RADIANT
HEATING SYSTEMS
THERMAL ZONE VALVE

SELL SHEET

Uponor Thermal Zone Valve

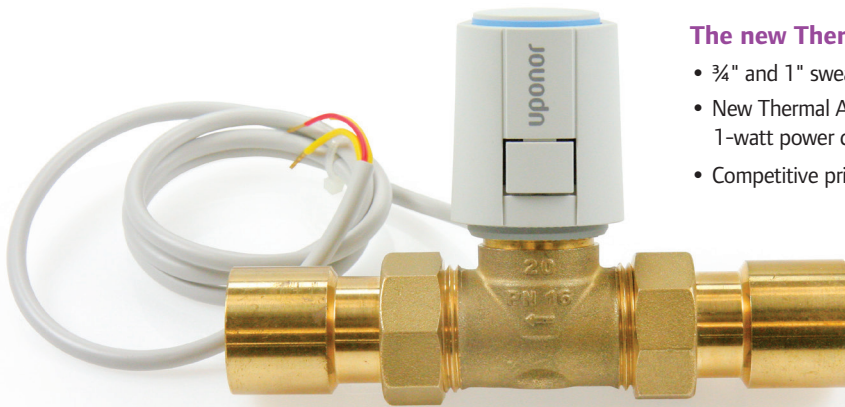
Uponor is now offering a new Thermal Zone Valve, four-wire (A3011075) which will replace the ¾" Thermal Zone Valve, four-wire (A3010525) and 1" Thermal Zone Valve, four-wire (A3010526).

The new Thermal Zone Valve (A3011075) includes:

- ¾" and 1" sweat adapters
- New Thermal Actuator, four-wire (A3023522) with lower, 1-watt power consumption
- Competitive pricing
